Subject: Exemption Request - Fire Protection Rule Scheduler Requirements
of 10 CFR 50.48(c)

Re: Cooper Nuclear Station

EXEMPTION

Diagram 2A

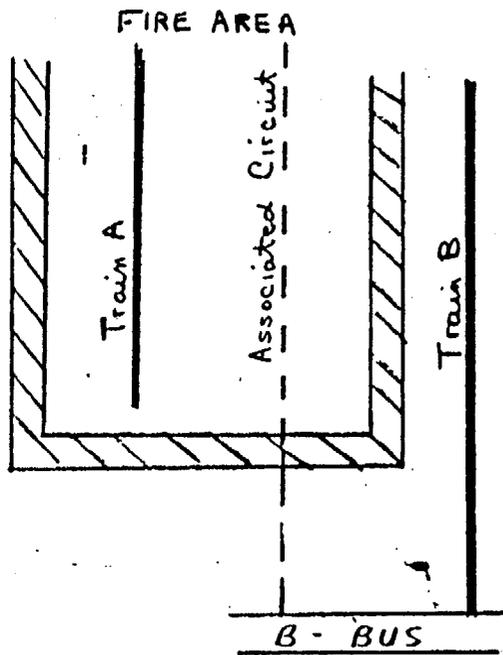
1. Have a physical separation less than that required by Section III.G.2 of Appendix R, and;
2. Have one of the following:
 - a. a common power source with the shutdown equipment (redundant or alternative) and the power source is not electrically protected from the circuit of concern by coordinated breakers, fuses, or similar devices (see diagram 2a), or

2. a. For a common power source case of associated circuit:

Provide load fuse/breaker (interrupting devices) to feeder fuse/breaker coordination to prevent loss of the redundant or alternative shutdown power source. To ensure that the following coordination criteria are met the following should apply:

Diagram 2B

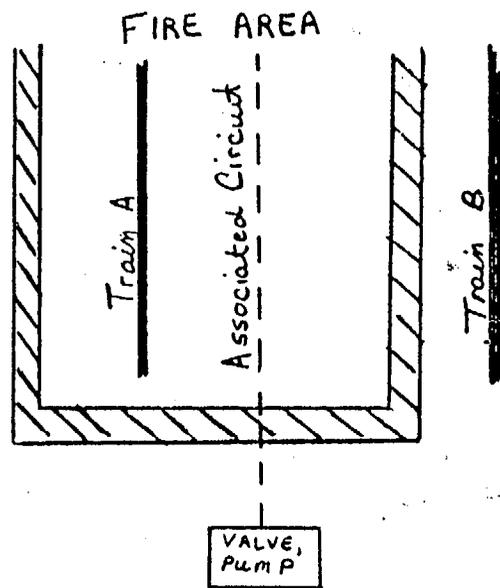
- b. a connection to circuits of equipment whose spurious operation would adversely affect the shutdown capability (e.g., RHR/RCS isolation valves, ADS valves, PORVs, steam generator atmospheric dump valves, instrumentation, steam bypass, etc.) (see diagram 2b), or

- b. For circuits of equipment and/or components whose spurious operation would affect the capability to safely shutdown:

- (1) provide a means to isolate the equipment and/or components from the fire area prior to the fire (i.e., remove power cables, open circuit breakers); or
- (2) provide electrical isolation that prevents spurious operation. Potential isolation devices include breakers, fuses, amplifiers, control switches; current XFRS, fiber optic couplers, relays and transducers; or
- (3) provide a means to detect spurious operations and then procedures to defeat the maloperation of equipment (i.e., closure of the block valve if PORV spuriously operates, opening of the breakers to remove spurious operation of safety injection);

Diagram 2C

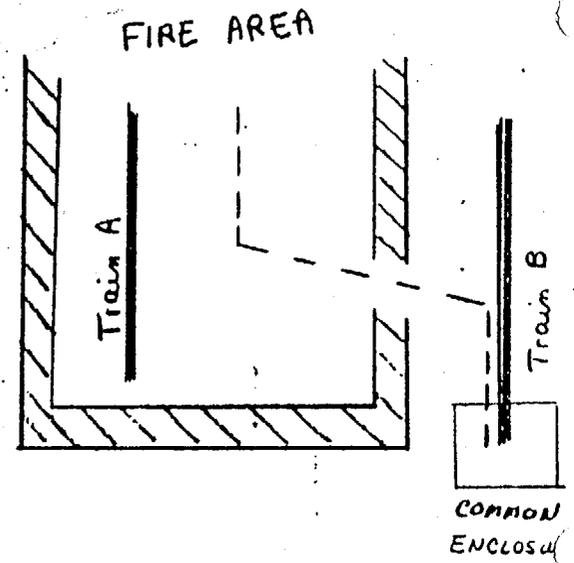
- c. a common enclosure (e.g., raceway, panel, junction) with the shutdown cables (redundant and alternative) and,
 - (1) are not electrically protected by circuit breakers, fuses or similar devices, or

- (2) will allow propagation of the fire into the common enclosure, (see diagram 2c).

c. For common enclosure cases of associated circuits:

- (1) provide appropriate measures to prevent propagation of the fire; and
- (2) provide electrical protection (i.e., breakers, fuses or similar devices)
